Access Compliance Report

Public Rights-of-Way

(Curb Ramps)

Intersection ID: 49101	Main Street: PROSPERITY_CROSSING_DR	Cross Street: DOCIA_CROSSING_RD	Location: SE
ADA ID: 9F59CA7A8B11	Ramp Type: Perp	Initial Pass/Fail: Fail	Overall Compliance: No
Severity Score: 25			
Codes/Mitigation Info/Possible Solution		Field Measurements/Component Compliance

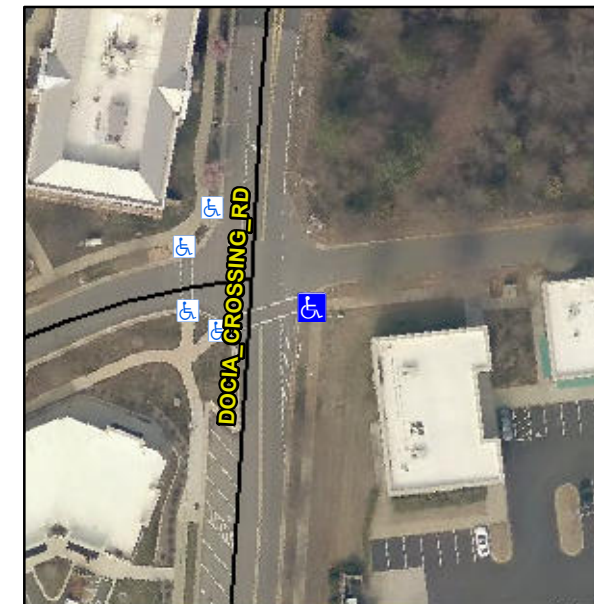
Compliance	Description	Data	Compliance	Description	Data
N/A	Ramp Length (in)	73.0	No	Ramp Slope (%)	13.1
Yes	Ramp Width (in)	48.0	Yes	Ramp XSlope (%)	0.7
N/A	Flare Type LT	N/A	N/A	Flare Type RT	N/A
N/A	Flare Slope LT (%)	N/A	N/A	Flare Slope RT (%)	N/A
N/A	Flare Traversable LT?	N/A	N/A	Flare Traversable RT?	N/A
N/A	Landing Length (in)	N/A	N/A	DWS Provided?	N/A
N/A	Landing Width (in)	N/A	N/A	DWS Contrast?	N/A
N/A	Landing Slope (%)	N/A	N/A	DWS Length (in)	N/A
N/A	Landing X Slope (%)	N/A	N/A	DWS Full Width?	N/A
N/A	Landing Curb? (Y/N)	N/A	N/A	DWS Offset (in)	N/A
N/A	Shared Landing?	N/A			
N/A	Gutter Ponding?	N/A	N/A	Gutter Slope (%)	N/A
N/A	Gutter Lip Ht (in)	N/A	N/A	Gutter X Slope (%)	N/A
N/A	Painted X Walk1?	Yes	N/A	Painted X Walk2?	N/A
	X Walk 1 Direction	To W		X Walk 2 Direction	N/A
N/A	X Walk 1 Width (in)	83.0	N/A	X Walk 2 Width (in)	N/A
	X Walk 1 Slope (%)	1.3		X Walk 2 Slope (%)	N/A
	X Walk 1 X Slope (%)	0.2		X Walk 2 X Slope (%)	N/A

Remove & Replace Entire Ramp.
